In the drawings

REMARKS

Figure 2

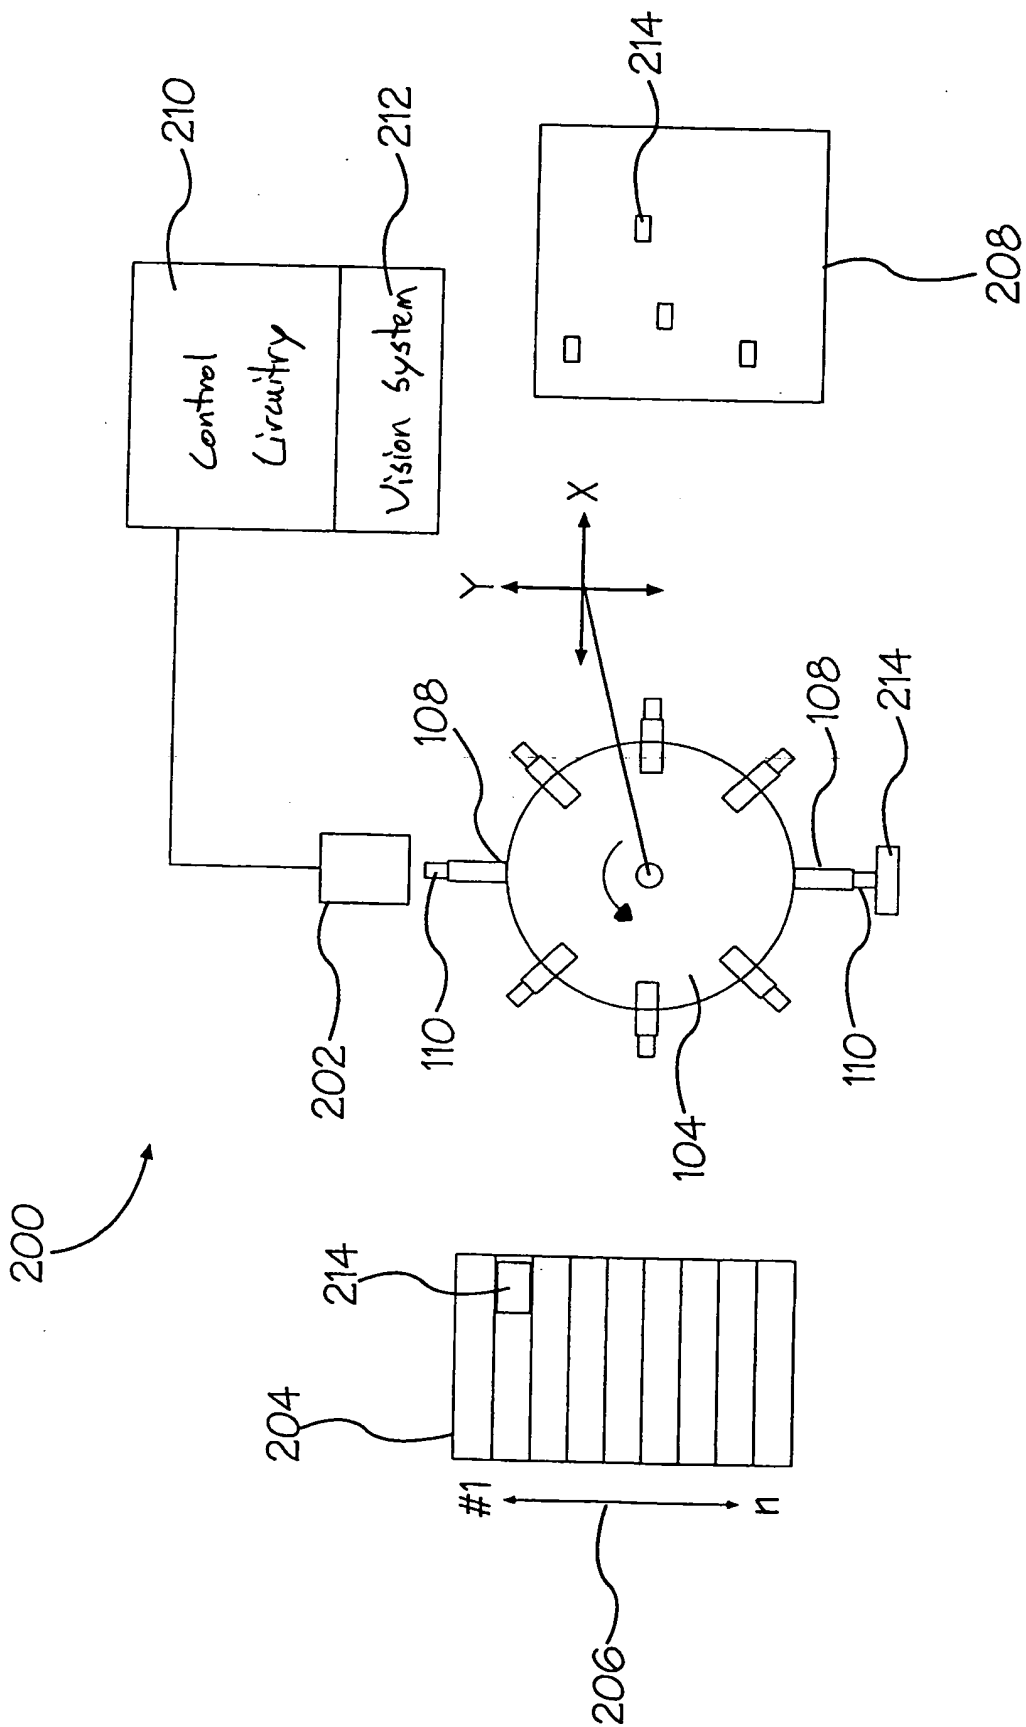
The drawings were objected to because in FIG. 2 box elements 202, 210 and 212 should be identified with appropriate legends. Applicant has included herewith replacement sheets intended to bring the drawings into allowance. Included anew in FIG. 2 are legends for box elements 210 and 212. However box element 202 numerically referencing at least one camera has not been modified with a legend due to inconvenience relative to the size of the box element 202. Also included in FIG. 2 is the tip of an arrow showing direction of rotation of rotatable frame 104. In addition, FIG. 3 has been modified to more accurately depict a timing diagram of vacuum nozzle image acquisition and processing during the placement cycle time in accordance with the inventive method. The modifications are intended to bring the depiction of FIG. 3 into more accurate compliance with the specification, so that “as may be seen, image acquisition and processing (calibration) for each vacuum nozzle are always completed within a single pick or place cycle.” (See Specification, page 9, lines 1-3).
